SELENIA®  
Dimensions®  
**3Dimensions™**

**1.10 and 2.1 Customer Release Notes**  
MAN-05762 Revision 002

For Software Versions 1.10 and 2.1

Part Number MAN-05762

#### 4.1.2 Skin Line Brightness Reduction Option

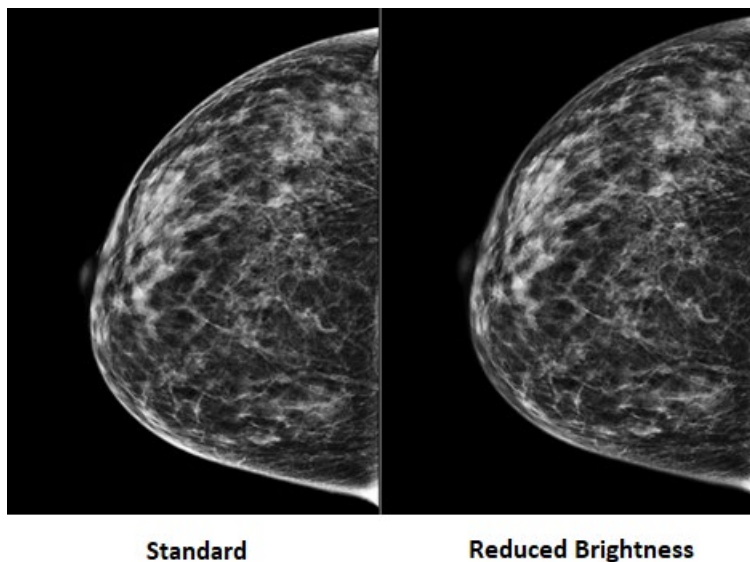
There is a new optional image processing setting for 2D imaging to reduce the brightness and overshadow of the skin on screening views. To enable this option, please contact your Hologic Field Service Engineer.

### 4.2.1 Support for Siemens Grayscale Presentation State (GSPS) Objects

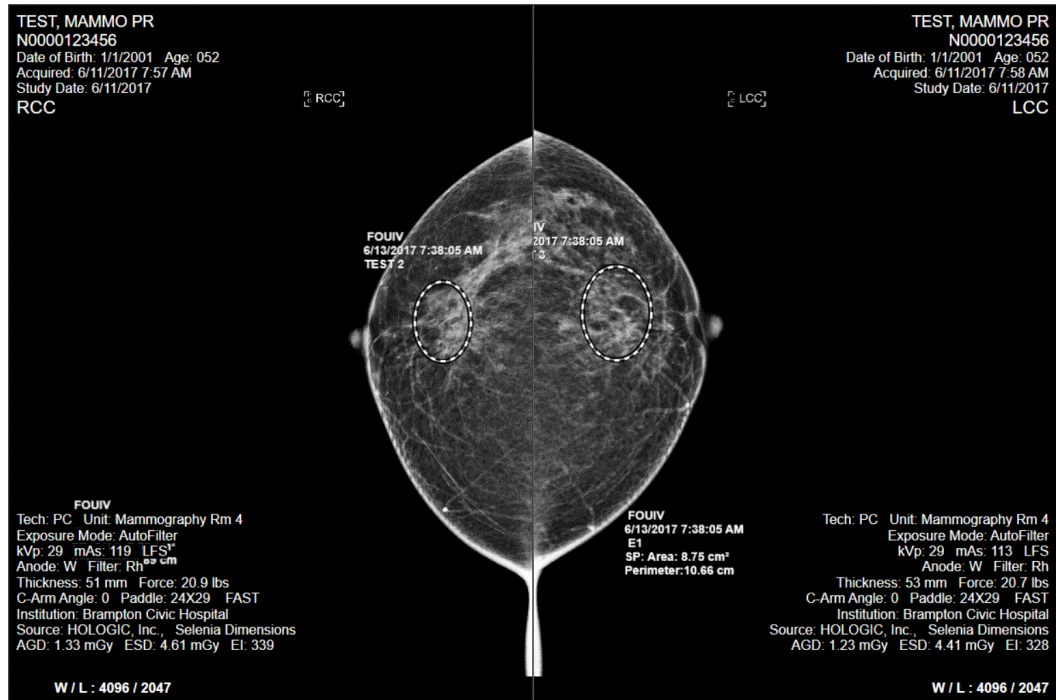
Grayscale Presentation State (GSPS) overlays created on Siemens Workstations can now be viewed on the Acquisition Workstation.
